ENVIRONMENTAL RE-EVALUATION CHECKLIST

Project Name: **Illinois Street Reconstruction (63102)**
 Project Number (State/Federal): 63102/STP-F-M-0663(4)
 Date: **9/16/2009**

Document Type and Approval Date: EA and FONSI 7/6/2005
 Re-Evaluation Number: 1
 Date of Last Re-Evaluation: N/A

FIGURE 1

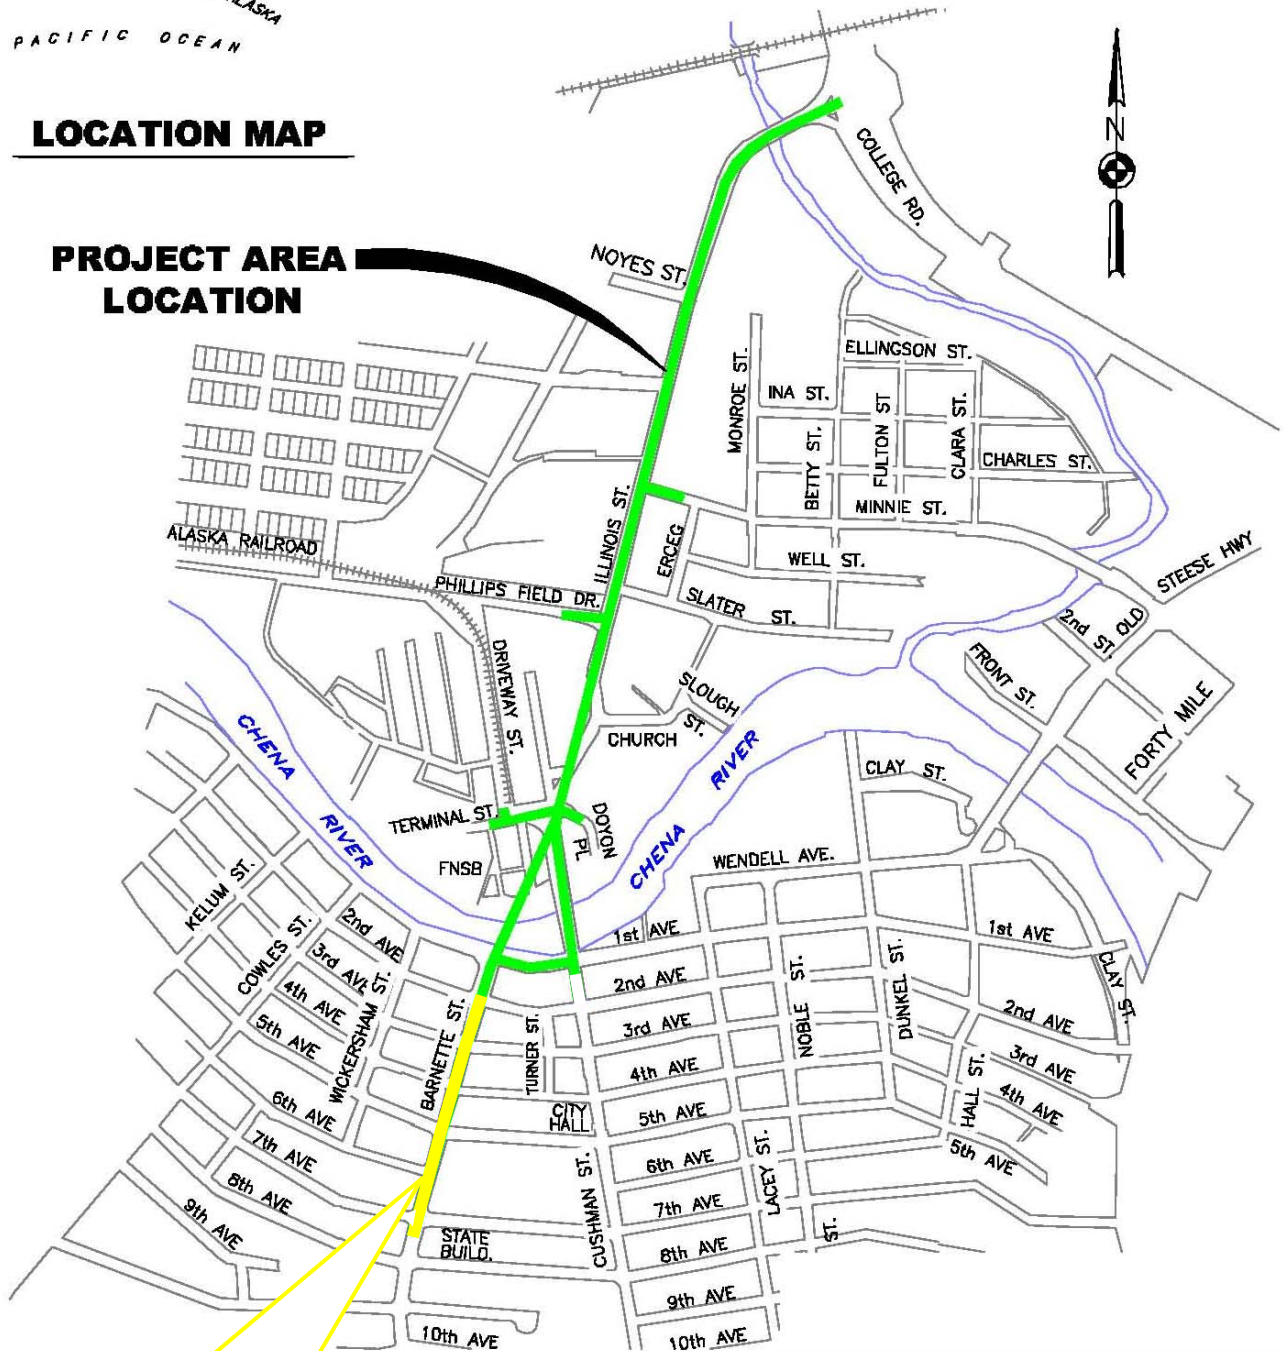
- *Barnette Street (7th Ave. – 1st Ave.) Deletion - The scope of the project would be reduced by deleting the segment of the project on Barnette Street between 1st Avenue and 7th Avenue, except for utility work between 1st and 2nd Avenue. See Figures 1 and 4. The details of the "Vision Fairbanks Downtown Plan" have yet to be worked out by the FNSB along this segment of Barnette Street. Removing this segment from the project until sufficient plan details are available would avoid project development that is incompatible with the future "Vision Fairbanks Downtown Plan". The 1st Ave. to 7th Ave. segment could be undertaken as a separate project in the future. A separate environmental document for the segment would be prepared at that time.*

- 2) *The segment of the project on Barnette Street between 1st Avenue and 7th Avenue would be removed from the project. This change will avoid development in the downtown area that may be incompatible with the "Vision Fairbanks Downtown Plan" for which details are yet to be worked out.*
